Consultant Advice Notice

Thornbury House – 716 High Street, Thornbury VIC 3071

Addendum to Acoustic Town Planning Report

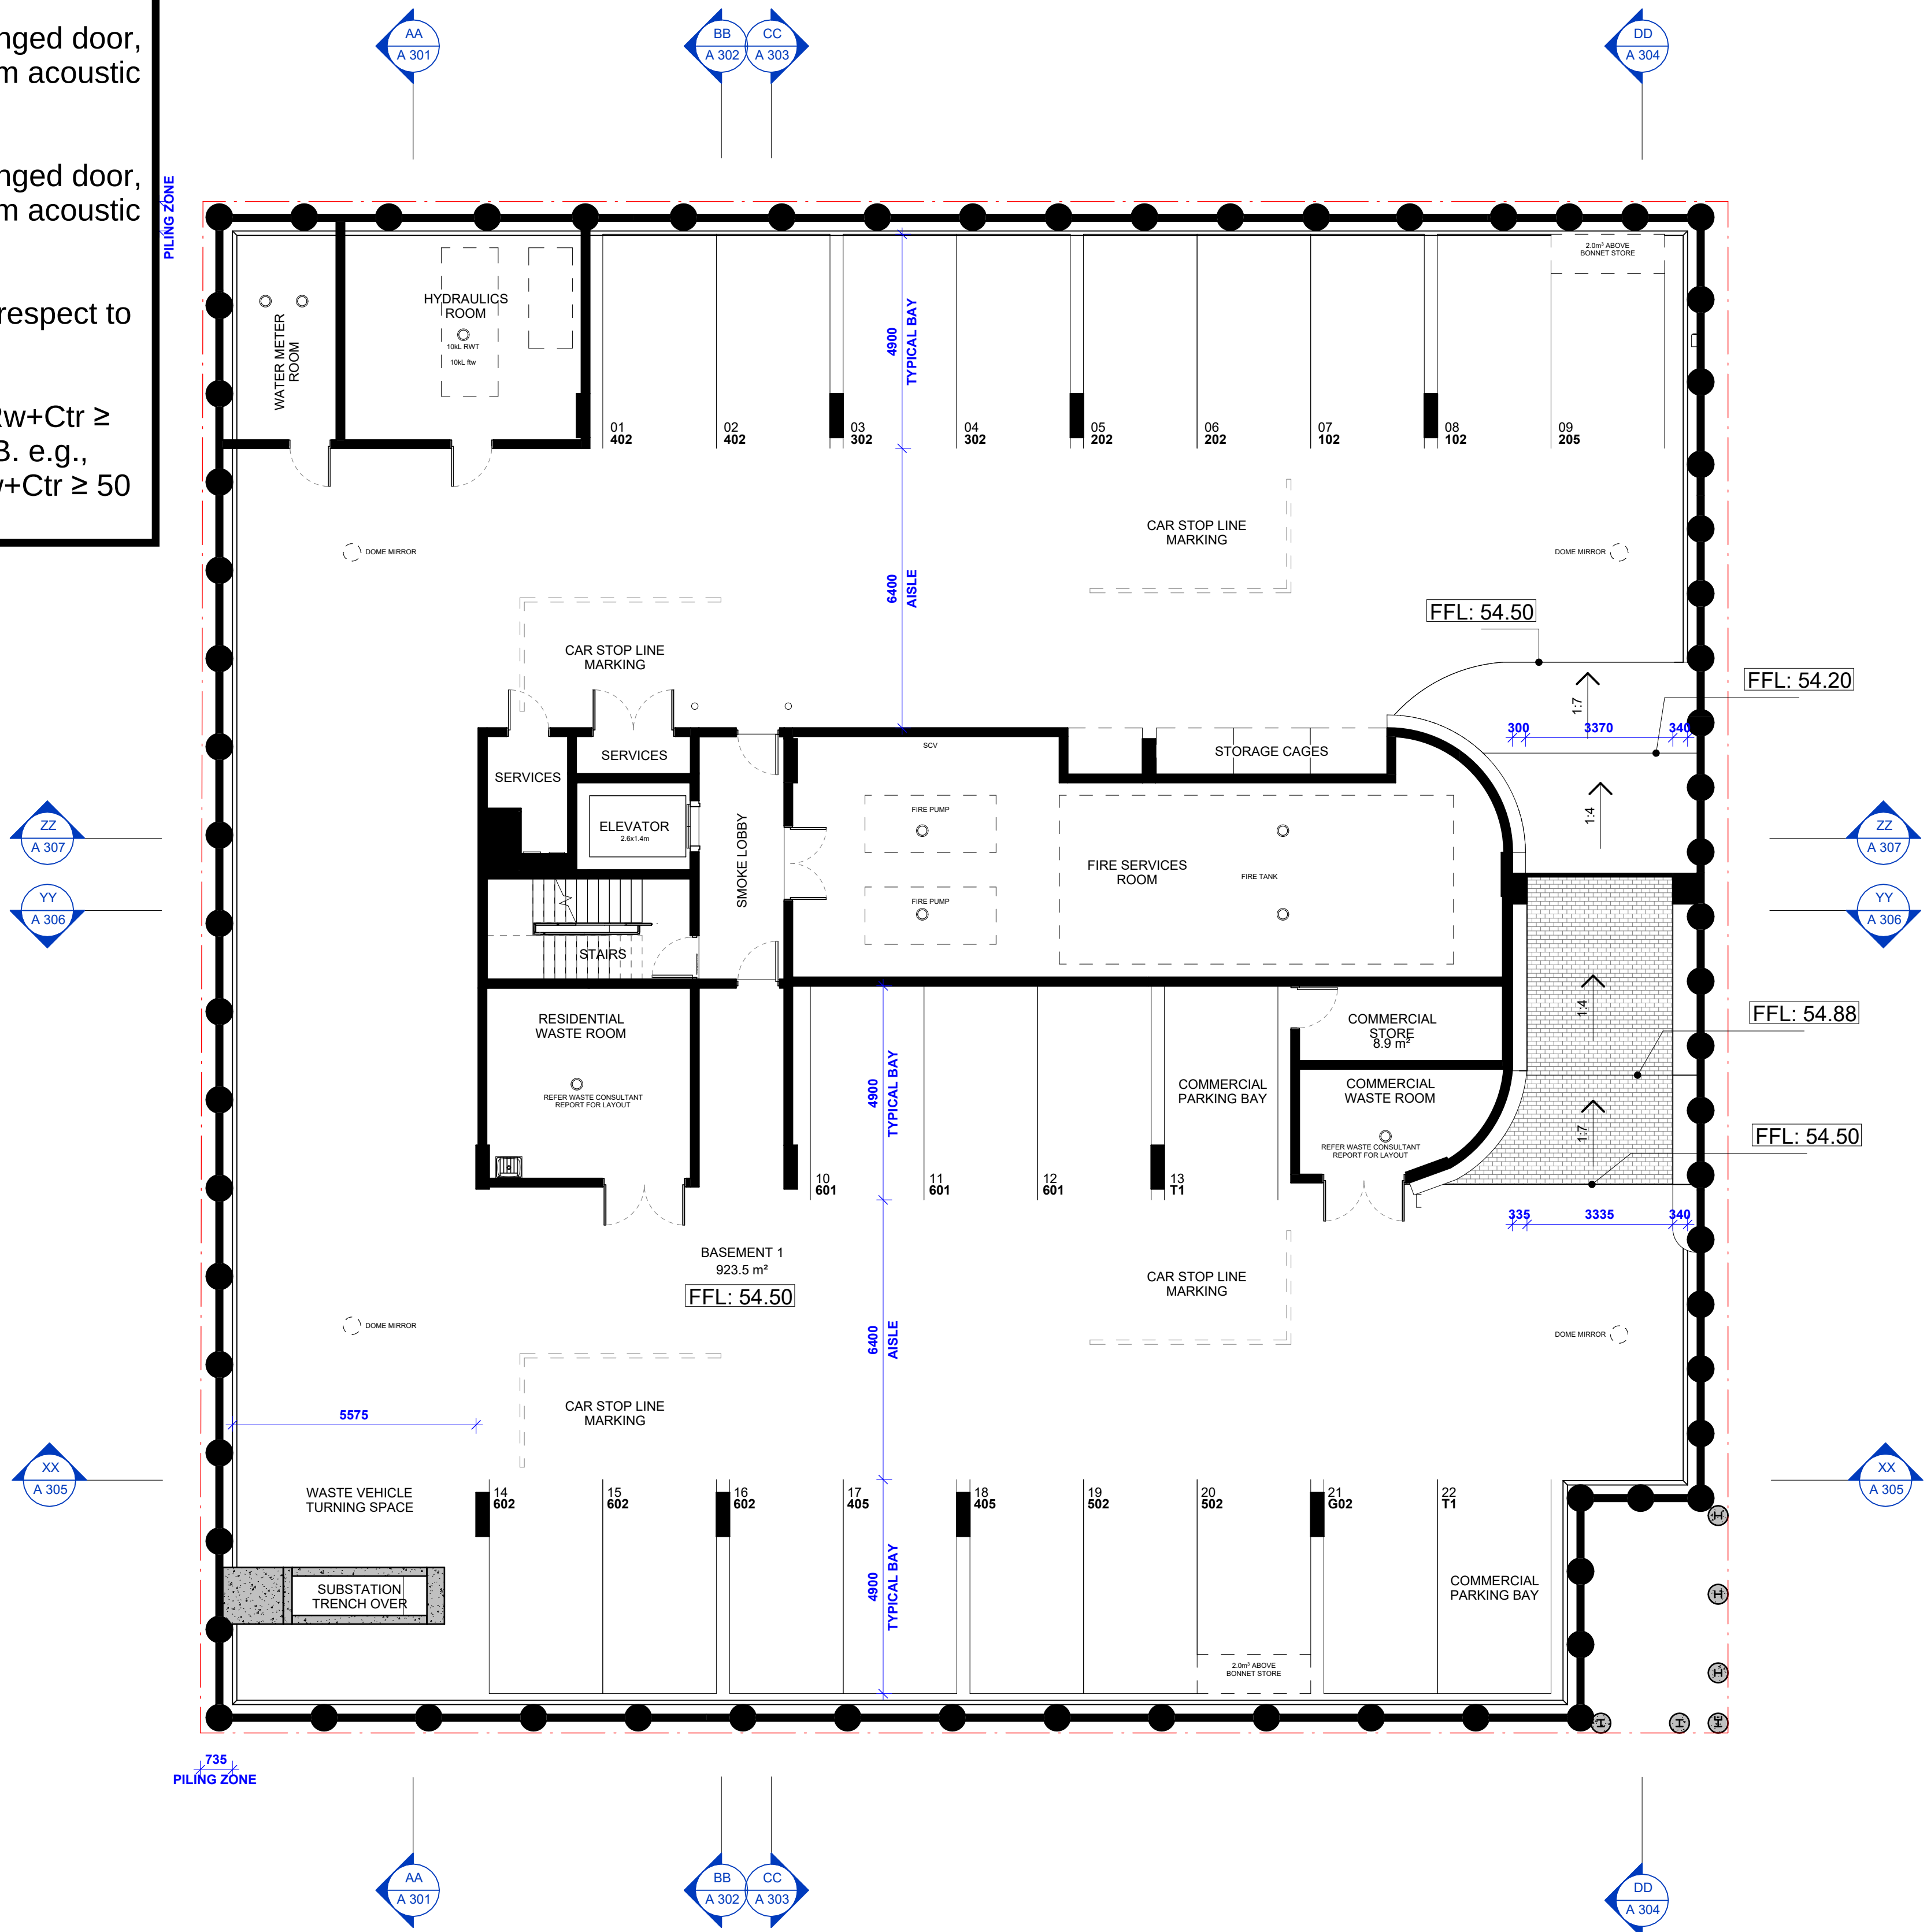
Fixed/awning glazing, sliding door or hinged door, including any frames and seals to have a minimum acoustic rating of Rw 40.

Fixed/awning glazing, sliding door or hinged door, including any frames and seals to have a minimum acoustic rating of Rw 38.

Fixed/awning glazing, sliding door or hinged door, including any frames and seals to have a minimum acoustic rating of Rw 36.
